# Access Compliance Report

### (Curb Ramps)

Intersection ID: 16072	Main Street: MONROE_RD	Cross Street: RICHLAND_DR	Location: NE
ADA ID: B108B647C199	Ramp Type: Perp	Initial Pass/Fail: Fail	Overall Compliance: No
Severity Score: 8.75			
Codes/Mitigation Info/Possible Solution		Field Measurements/Component Compliance

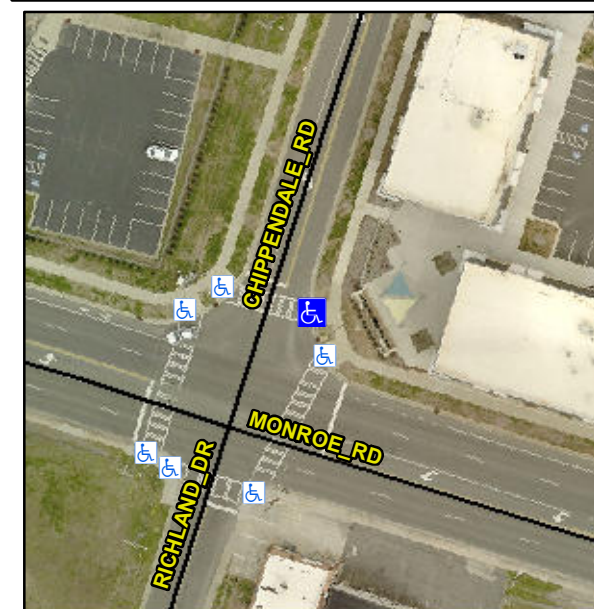
**Not Found, R304.5.1**

Compliance	Description	Data	Compliance	Description	Data
N/A	Ramp Length (in)	97.0	Yes	Ramp Slope (%)	7.0
No	Ramp Width (in)	45.5	Yes	Ramp XSlope (%)	1.8
N/A	Flare Type LT	N/A	N/A	Flare Type RT	N/A
N/A	Flare Slope LT (%)	N/A	N/A	Flare Slope RT (%)	N/A
N/A	Flare Traversable LT?	N/A	N/A	Flare Traversable RT?	N/A
N/A	Landing Length (in)	N/A	N/A	DWS Provided?	N/A
N/A	Landing Width (in)	N/A	N/A	DWS Contrast?	N/A
N/A	Landing Slope (%)	N/A	N/A	DWS Length (in)	N/A
N/A	Landing X Slope (%)	N/A	N/A	DWS Full Width?	N/A
N/A	Landing Curb? (Y/N)	N/A	N/A	DWS Offset (in)	N/A
N/A	Shared Landing?	N/A			
N/A	Gutter Ponding?	N/A	N/A	Gutter Slope (%)	N/A
N/A	Gutter Lip Ht (in)	N/A	N/A	Gutter X Slope (%)	N/A
N/A	Painted X Walk1?	Yes	N/A	Painted X Walk2?	N/A
	X Walk 1 Direction	To NW		X Walk 2 Direction	N/A
N/A	X Walk 1 Width (in)	115.0	N/A	X Walk 2 Width (in)	N/A
	X Walk 1 Slope (%)	0.8		X Walk 2 Slope (%)	N/A
	X Walk 1 X Slope (%)	1.4		X Walk 2 X Slope (%)	N/A

**Remove & Replace Entire Ramp.**
